**DEL WEBB AT MIREHAVEN PHASE 3 & 4  
 (TRACT M AND TRACT N-2-A-1, WATERSHED)**

Re: Del Webb at Mirehaven Phase 3&4 Grading and Drainage Plan and Drainage Report  
Engineers Stamp Dated: 05/10/2018 (H09D017G)

Enclosed are responses to the comments provided on June 19, 2018. Responses are listed in red below.

CITY PROJECT NO. H-8/9 SHEET 2 OF 4

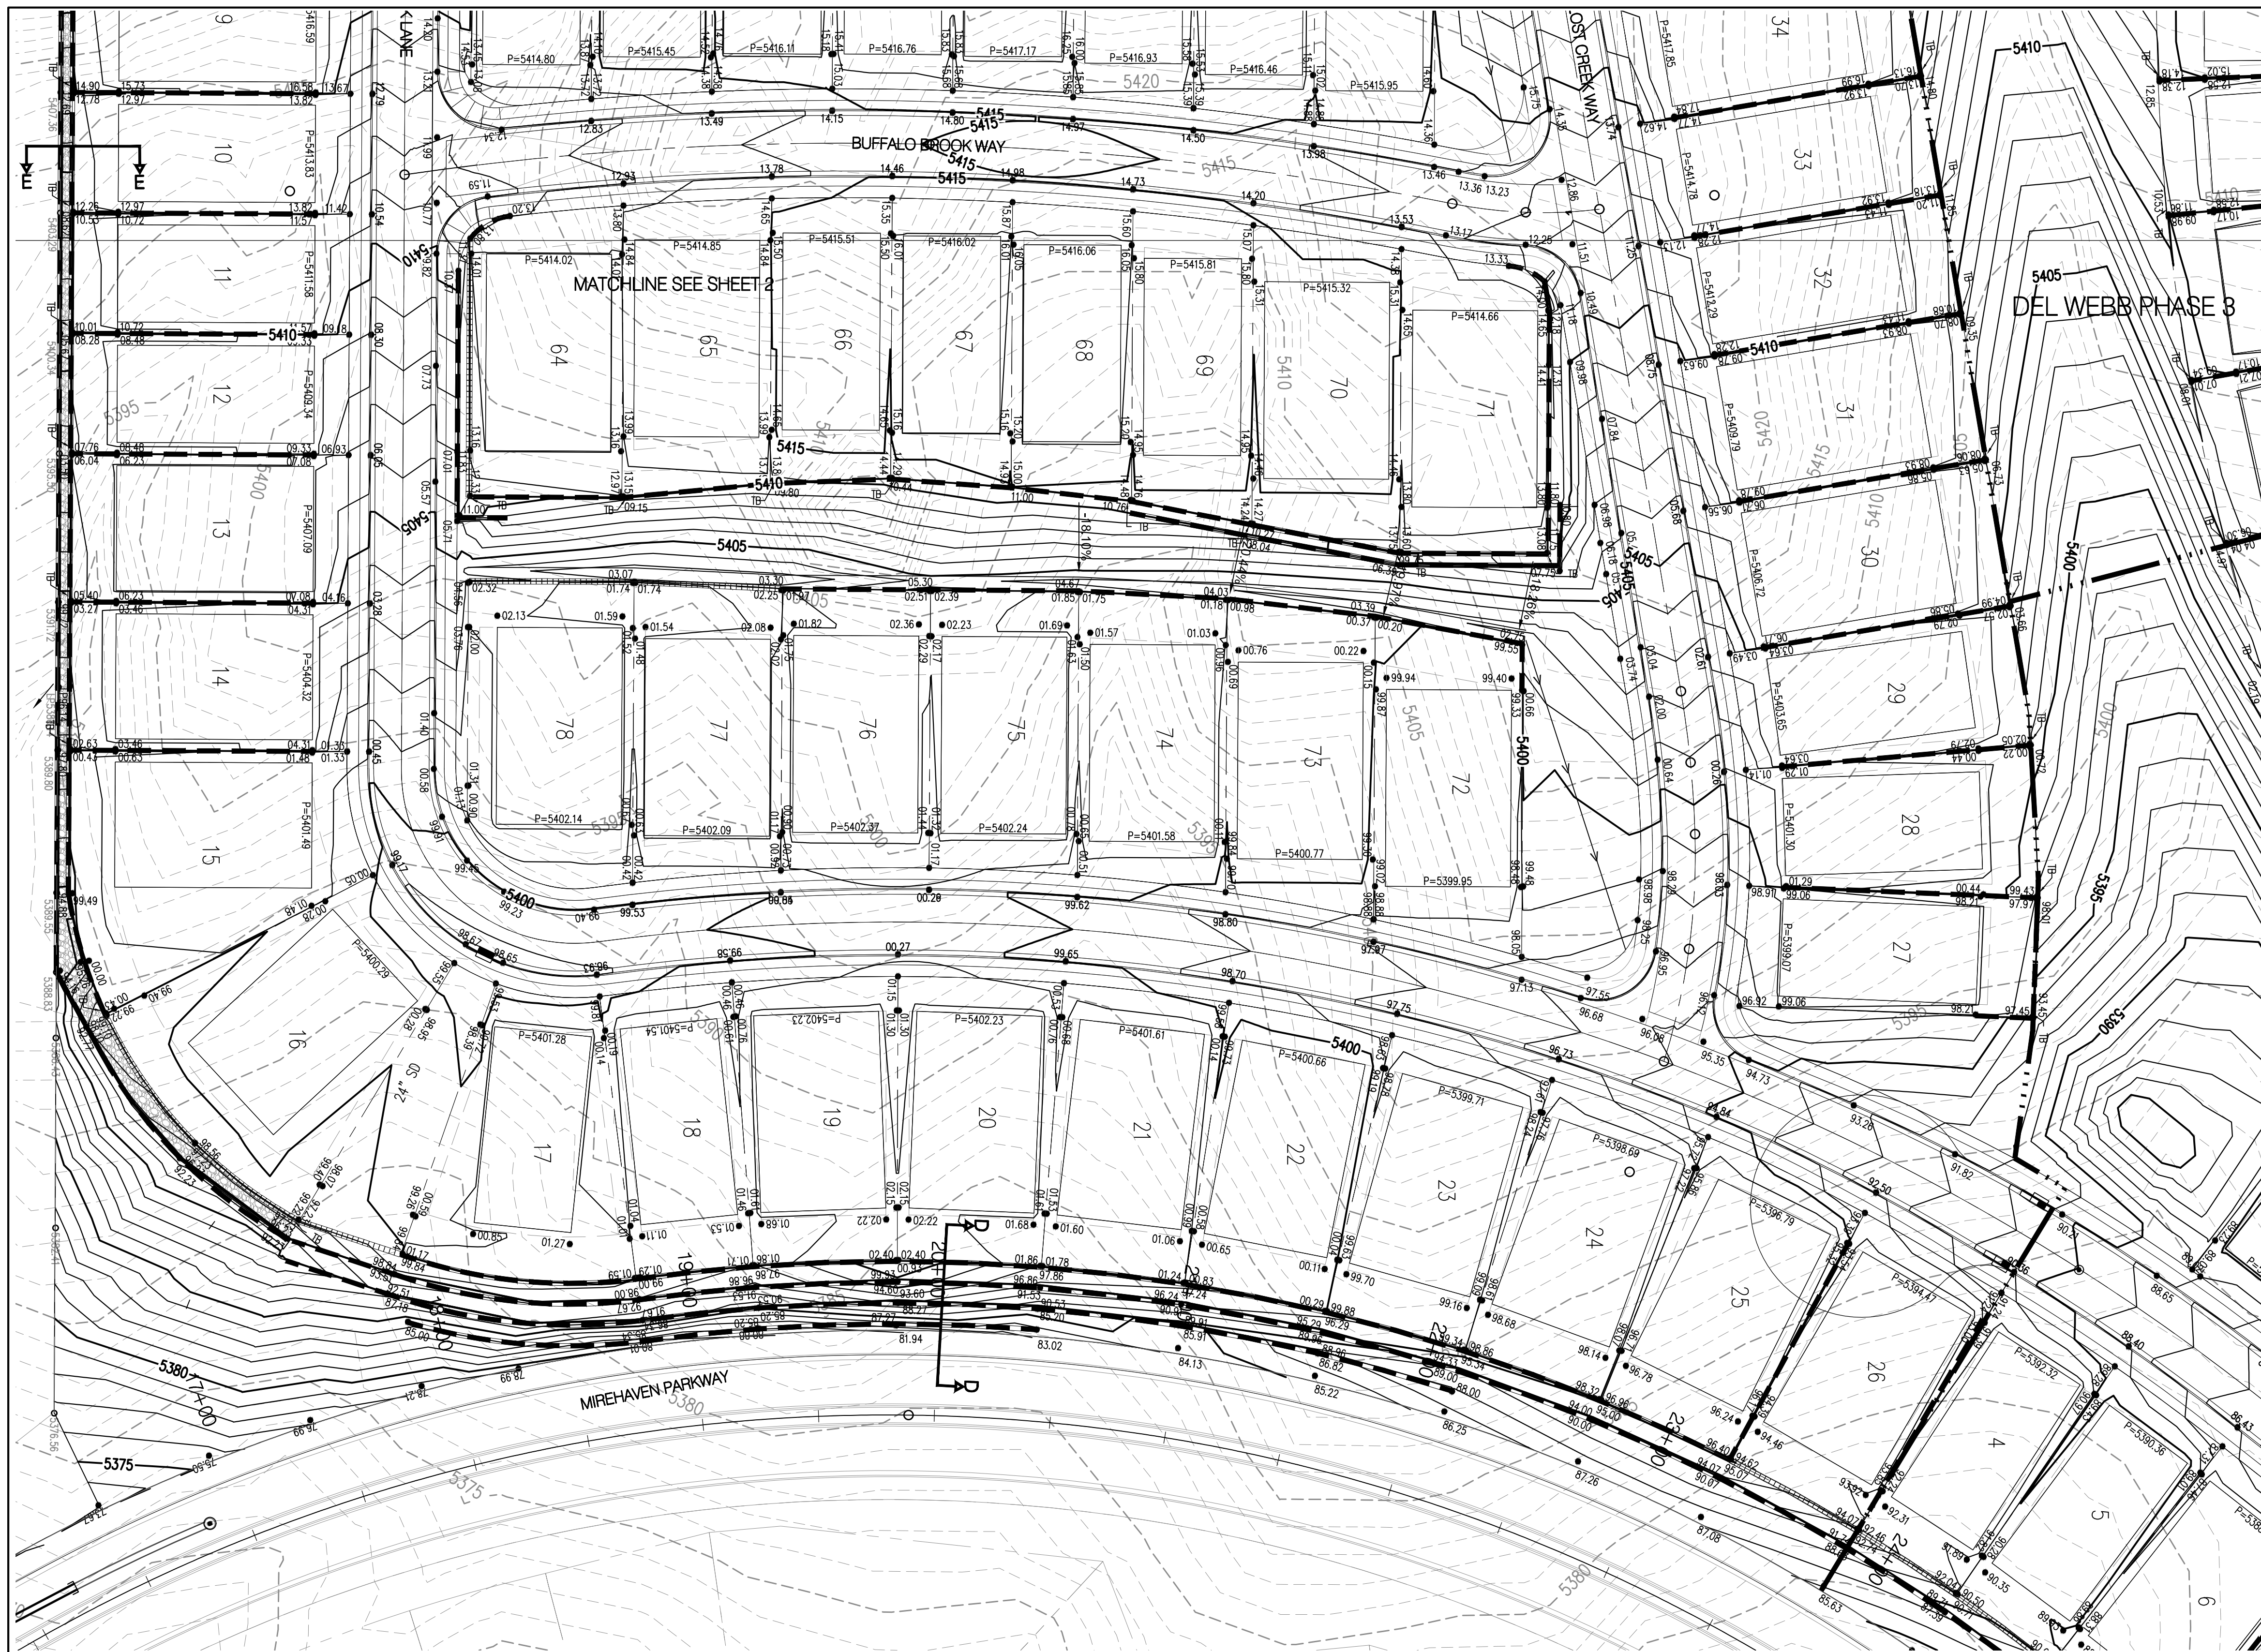
2. Provide written permission from the adjoining property owners if walls (including footers and excavation for footers) encroach into adjacent properties. Unit 4 sheet 2, Section CC shows a wall in cut centered on the west boundary line. The section must be modified to show no encroachment into the monument or provide written permission from neighbor. **Along the APS boundary the wall will be offset so the footer is not in private property or an L-footer will be utilized. Cross-section E-E has been updated to reflect this. As for the Petroglyph National Monument, Cross-section C-C has been updated to reflect this the wall is located 5' from boundary.**
